Remarks

This Response is provided in response to a non-final Office Action mailed June 2, 2004. The Office Action rejected claim 16 under 35 U.S.C. §102(b) as being anticipated by prior art, and claim 22 has been withdrawn from consideration and has been canceled by the Applicant. The Office Action further provided certain objections to the specification and drawings.

Amendments to the Drawings

FIG. 17

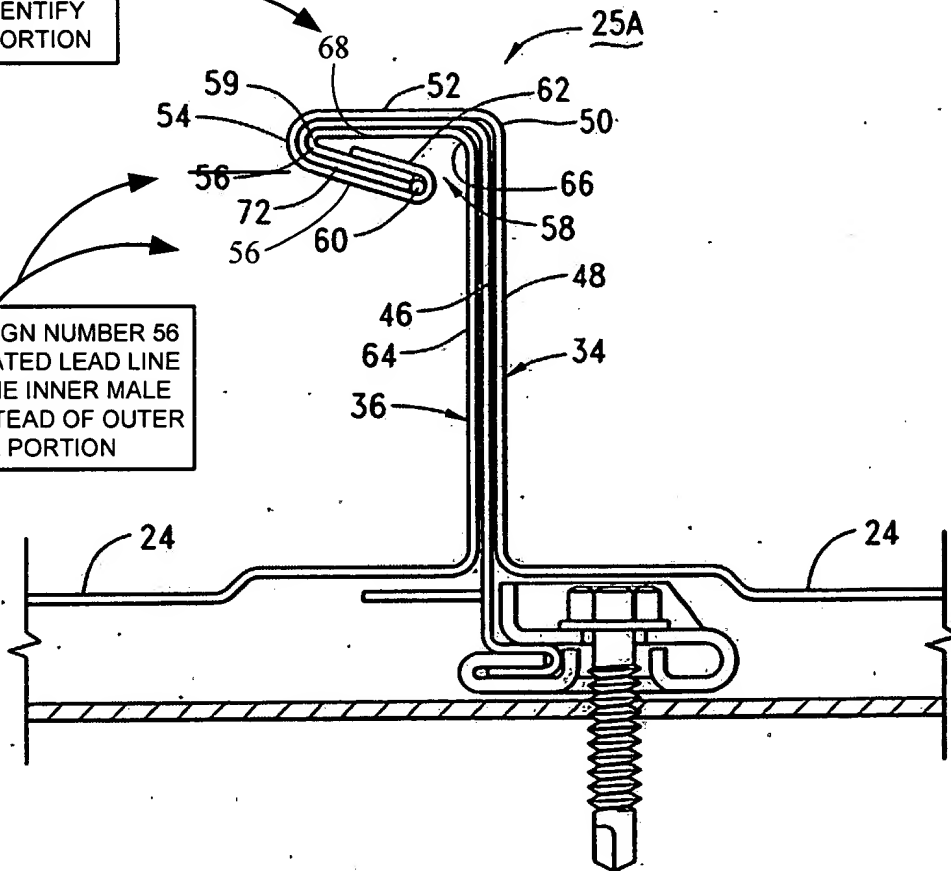
FIG. 13 has been amended to add reference numeral “98” as required by the Examiner. FIG. 17 has been amended to add reference numeral “68” and reference numeral “56” has been moved to show the outer female portion, instead of the inner male portion.

ADDED SIGN NUMBER 68
 AND ITS ASSOCIATED
 LEAD LINE TO IDENTIFY
 THE FIFTH LEG PORTION

REPLACED SIGN NUMBER 56
 AND ASSOCIATED LEAD LINE
 TO SHOW THE INNER MALE
 PORTION INSTEAD OF OUTER
 FEMALE PORTION

FIG. 26

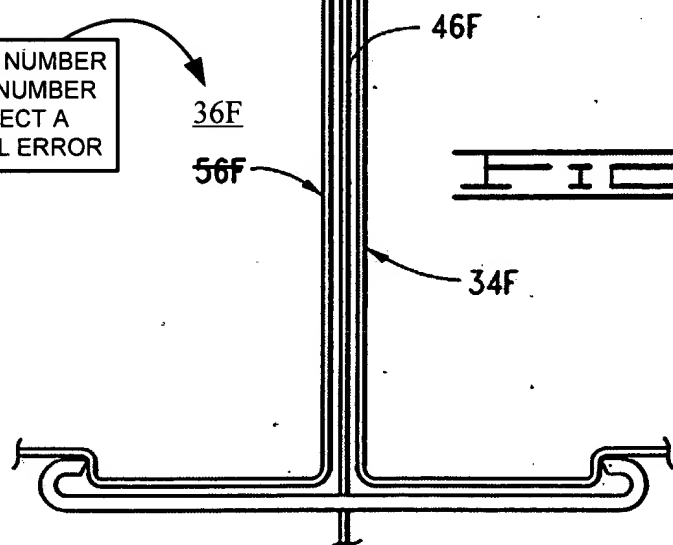
FIG. 26 has been amended to replace reference numeral “56F” with reference numeral “36F” to correct a typographical error.

REPLACED SIGN NUMBER
56F WITH SIGN NUMBER
36F TO CORRECT A
TYPOGRAPHICAL ERROR
